Throughout the summer the Town Hall Project has progressed with the appointed architect, additional consultants and staff. On 22<sup>nd</sup> July 2021 Cllr Lyn Walters stepped down from the Town Hall Working Group. Two Working Group meetings have also been held. Please see details below.

**Working Group Meeting Friday 23<sup>rd</sup> July 2021**

Members reviewed a Proposed Site Plan and Ground Floor Plan produced by the architect and discussed the following:

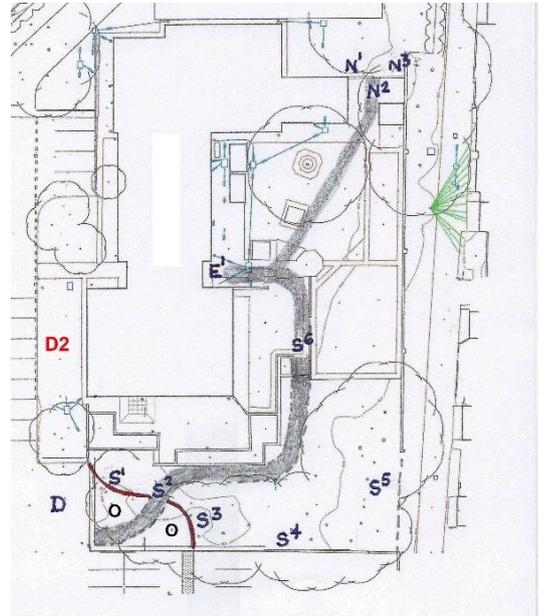
The architect proposed a suggestion for the fencing treatment along the South boundary of the property which can be seen from the Wellness Village. He suggested an elegant conservation style approach of black wrought iron bow top fences to a height of 2m approx. and to introduce number of laser cut plaques between the railings to help break the elevation and to illustrate the Town Council history etc. They could be photographs which a company can scan and then laser cut the black sheets from the computer and can be installed in bespoke fence panels.

- Members of the Working Group considered laser cut panels for the boundary railings however it was noted that the Council have experience with laser panels on another project in the Town Centre and expressed concern about cost, health & safety concerns (from children getting fingers trapped) and timescales to incorporate these. For these reasons it was decided that the project at the Town Hall should progress with standard bow topped railings that should be simple and economical.
- Members considered wrought/fabricated iron railings versus cast iron (conservation) railings. Bob Burns advised that he had sought costs from a local supplier and was told that the cast iron railings are 3-5 times more expensive than round or square fabricated railings.

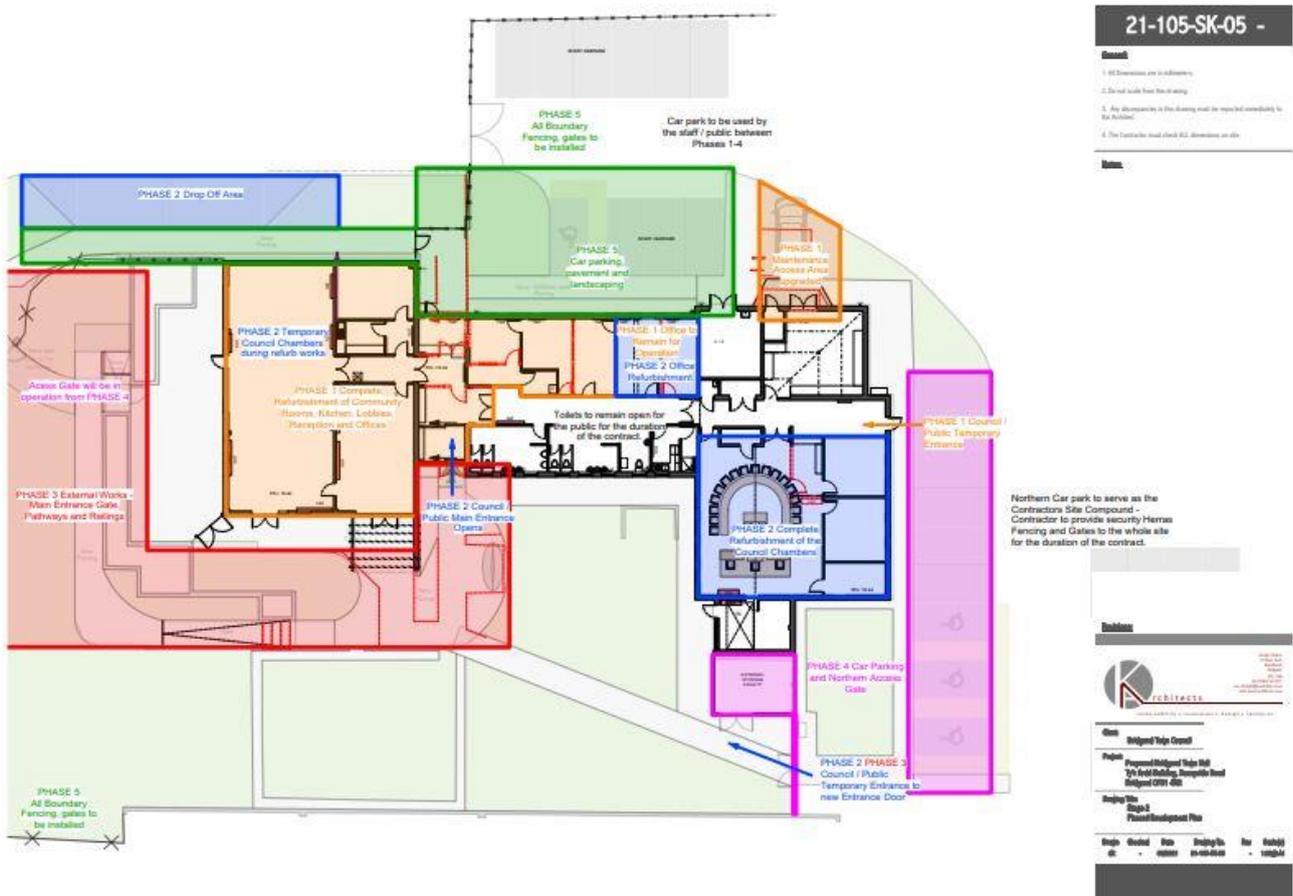
- a) New Memorial Gate – This is permitted development under Part 12 of the GPDO 1995 as it is less than 4m, is set into the site, is not within the setting of a listed building, is on your land and a Town Council is classed as a Local Authority under the regs.

- b) New railings – The majority of the railings can go up to 2m in height under pd rights (Part 2A) (as they are set back off the highway) apart from the element directly fronting the adjacent lane to the east of the building. As this is necessary for security, and to avoid having to submit an application for a 1.4m high railing at this point, I would suggest setting the railing back into the site at this point by around a metre as the railings will still be see-through and should not cause any visual impairment to users of the lane.

- c) New graded footway from private road drop-off to Town Hall floor level – this element does not require planning permission as the internal road will not be a classified highway and as long as there is no significant raising or lowering of the land as a form of engineering operation.

- d) New landscaping adjacent to the footway – this does not require planning permission as it is not classed as development and is supported.

- a) The memorial gate design is below the 4m height. It has been designed to be as low as it can go to help keep the cost down. The height of the gate can be increased, but so will the cost.
- b) Perimeter / boundary fence has been designed at a 2m height as this is the minimum height for a security fence. The planners comment suggest that this fence is to be set 1m inside from the kerb edges – apart from the East side.
- c) There is only a 150 – 200mm level difference to this area and will not be significant enough to be classed as an engineering operation.
- d) A decision will need to be made if this footpath is to be one of the following:
  - a) Permeable resin bonded pathway, b) Tarmac pathway or c) Paving slabs pathway

Image 1: Proposed Quotation Plan

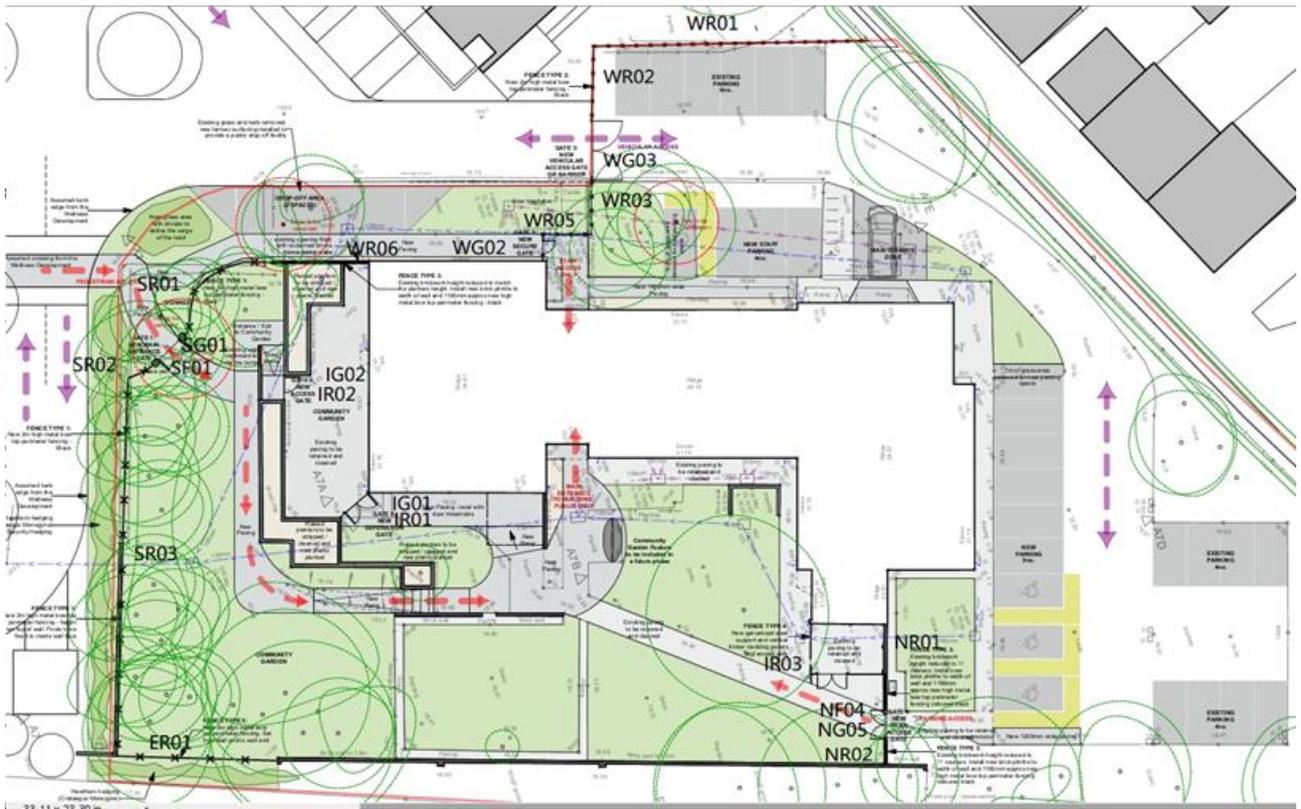
The draft brief introduces itemised sections (also refer to Image 1: Proposed Quotation Plan below) of Railings and Gates to provide more detailed analysis of each quotation and flexibility to the Town Council as to need.

The Internal Railings and Gates should be evaluated as to whether they are really necessary.
